# CITY OF ALBUQUERQUE

**Re: Sundoro South Subdivision Units 5,6,7 Drainage Report  
Engineer's Stamp dated 10-29-04 (J9/D19A)**

# **DRAINAGE MANAGEMENT PLAN**

**SUNDORO SOUTH**

TITLE: **SUNDORO SOUTH UNIT 5  
GRADING & DRAINAGE PLAN**

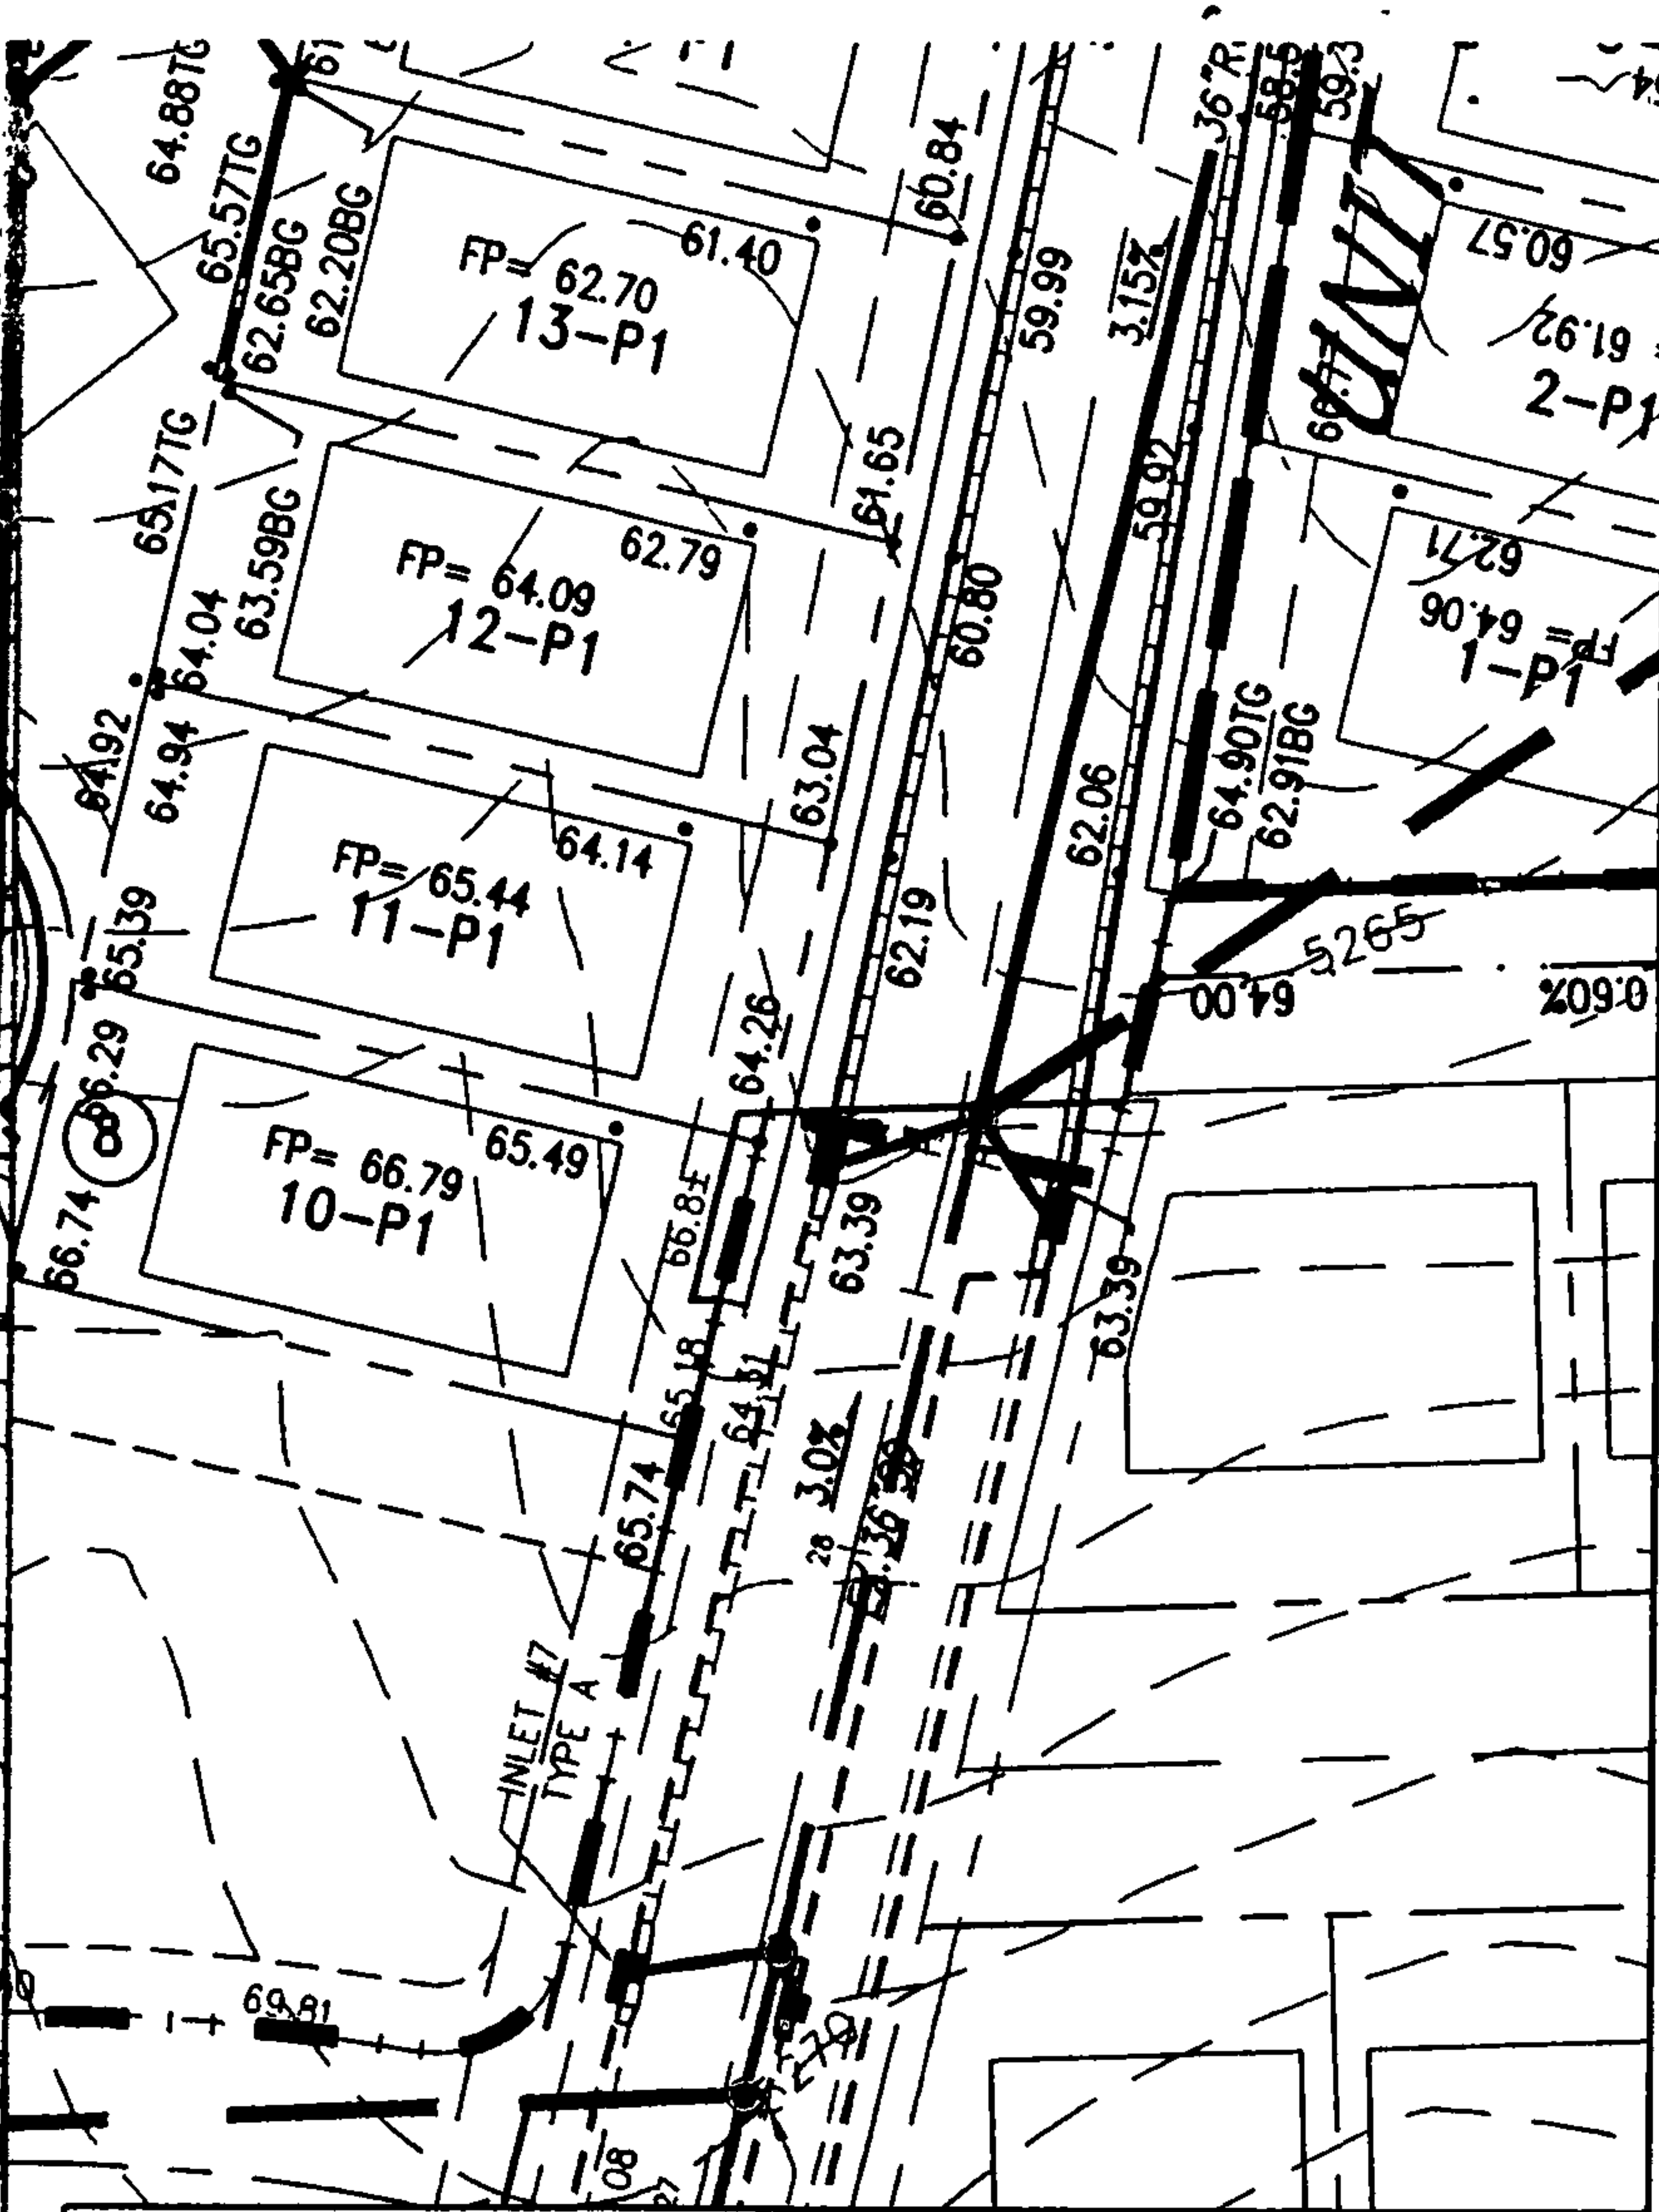
Based upon the information provided in your Engineer's Certification Submittal dated 06/01/2006, the above referenced plan cannot be approved for Grading and Drainage Certification for Release of Financial Guaranty.

1. The Approved Grading and Drainage Plan has an Engineer's Seal date of 02/15/2005 not 10/29/2004 as indicated in your submittal. (See attached copies of Grading Plan approval letter and Engineer's Seal).
